Access Compliance Report

Public Rights-of-Way

(Curb Ramps)

Intersection ID: N/A	Main Street: MORABLIN_DR	Cross Street: CARAGANA_CT	Location: NW
ADA ID: A02076DDA59F	Ramp Type: PerpDiag	Initial Pass/Fail: Fail	Overall Compliance: No
		Severity Score: 60

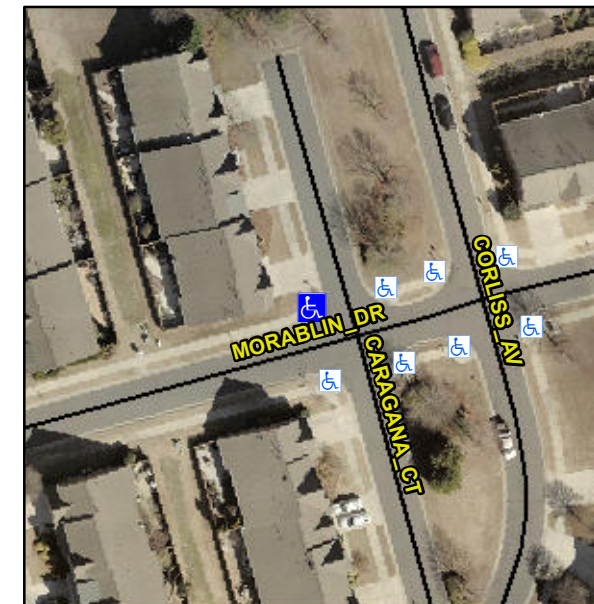
Not Found, R304.5.1, R304.5.3

Compliance	Description	Data	Compliance	Description	Data
N/A	Ramp Length (in)	108.0	Yes	Ramp Slope (%)	7.3
No	Ramp Width (in)	27.0	No	Ramp XSlope (%)	7.5
N/A	Flare Type LT	N/A	N/A	Flare Type RT	N/A
N/A	Flare Slope LT (%)	N/A	N/A	Flare Slope RT (%)	N/A
N/A	Flare Traversable LT?	N/A	N/A	Flare Traversable RT?	N/A
N/A	Landing Length (in)	N/A	N/A	DWS Provided?	N/A
N/A	Landing Width (in)	N/A	N/A	DWS Contrast?	N/A
N/A	Landing Slope (%)	N/A	N/A	DWS Length (in)	N/A
N/A	Landing X Slope (%)	N/A	N/A	DWS Full Width?	N/A
N/A	Landing Curb? (Y/N)	N/A	N/A	DWS Offset (in)	N/A
N/A	Shared Landing?	N/A			
N/A	Gutter Ponding?	N/A	N/A	Gutter Slope (%)	N/A
N/A	Gutter Lip Ht (in)	N/A	N/A	Gutter X Slope (%)	N/A
N/A	Painted X Walk1?	No	N/A	Painted X Walk2?	No
	X Walk 1 Direction	To S		X Walk 2 Direction	To E
N/A	X Walk 1 Width (in)	N/A	N/A	X Walk 2 Width (in)	N/A
	X Walk 1 Slope (%)	5.2		X Walk 2 Slope (%)	2.1
	X Walk 1 X Slope (%)	0.3		X Walk 2 X Slope (%)	3.9

Remove & Replace Curb Ramp With Two New Directional Ramps or Equivalent.
